Product Change Notice (PCN)

Subject: Site addition of Wafer Process and Wafer Test for RH850/F1K Series.

PCN#: [HDL2-0338]
PC-MCU-A021A/E

Production Flow

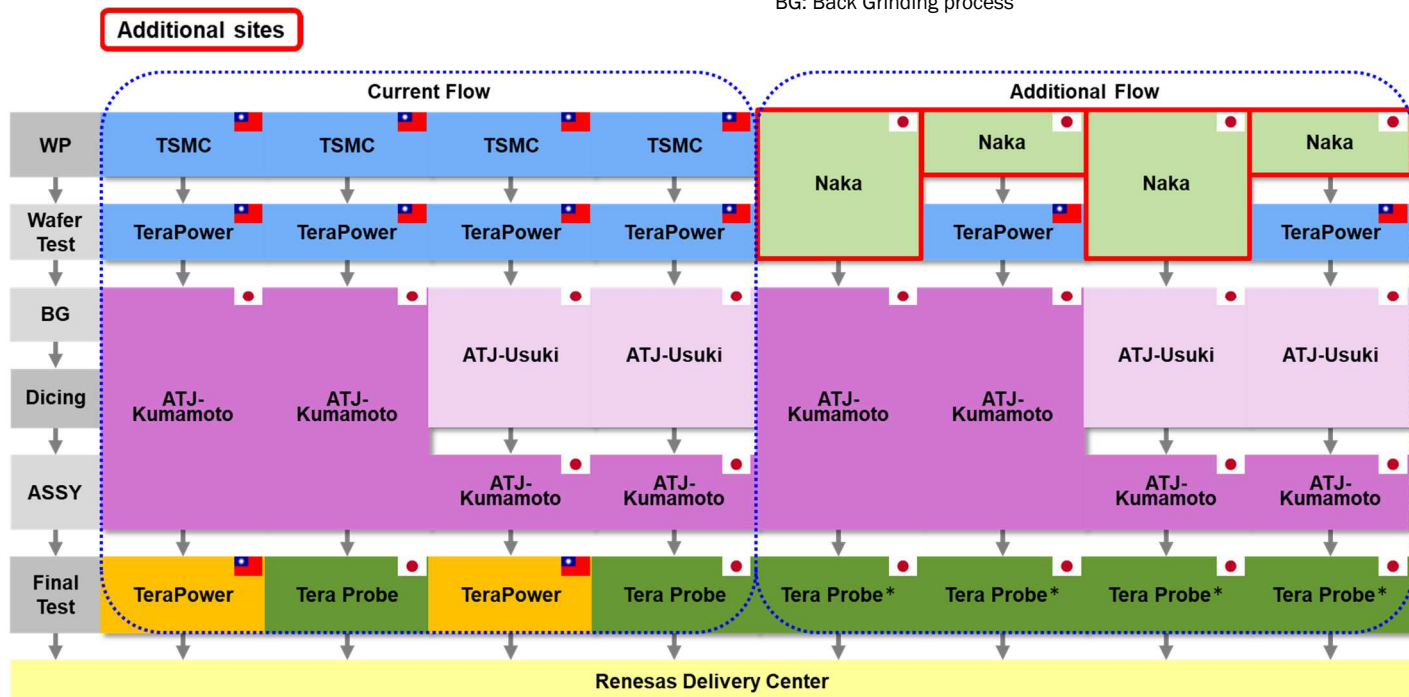
Items		Current	After site addition
Part Number		No change	
Outline		LQFP-100pin, 144pin, 176pin	<--(No change)
Wafer and Wafer Test Process	Wafer Process Site	TSMC	TSMC and Naka
	Wafer Test Site	TeraPower	TeraPower and Naka
Assembly Process	Assembly Site	ATJ-Kumamoto	<--(No change)
Mark		Change (Refer to "Mark Specification")	
Label		Change (Refer to "Label Specification")

Items		TSMC	Naka	Remarks
Wafer Process	Wafer	TSMC Wafer	Naka Wafer	
	Process	RV40F(40nm) Process A (TiN/SiO2/SiN)	RV40F(40nm) Process B (SiON/SiO2/SiN)	The material change of TOP-Metal
Assembly Process	Die-Bonding Material	Die-Bonding material A	<--	
	Lead Frame	Lead Frame A	<--	
	Wire	Cu-wire A	<--	
	Mold Resin	Mold resin A for Cu-wire	<--	
	Plating	Pure Sn	<--

*TeraPower is not used as FT site in the additional flow.

Mark Specification:

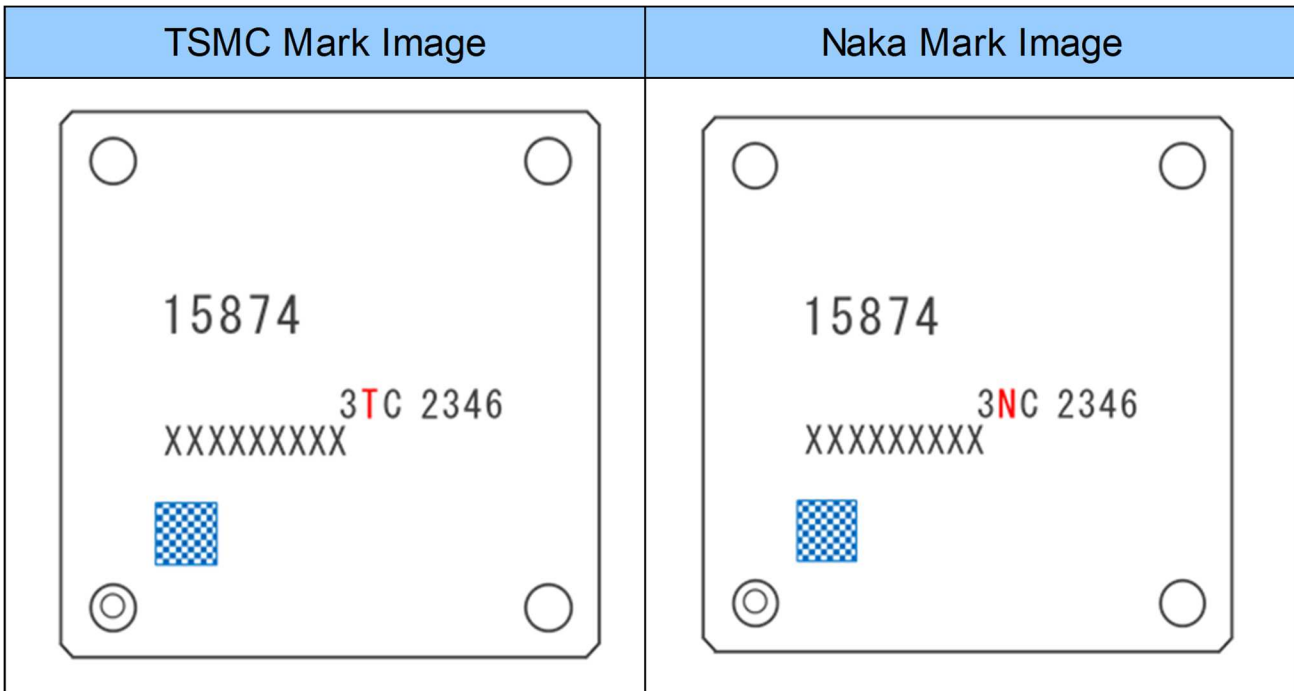
Mark Example: R7F7015874AFD-C#BA3 (F1K 176pin)

The red character is different between TSMC and Naka.
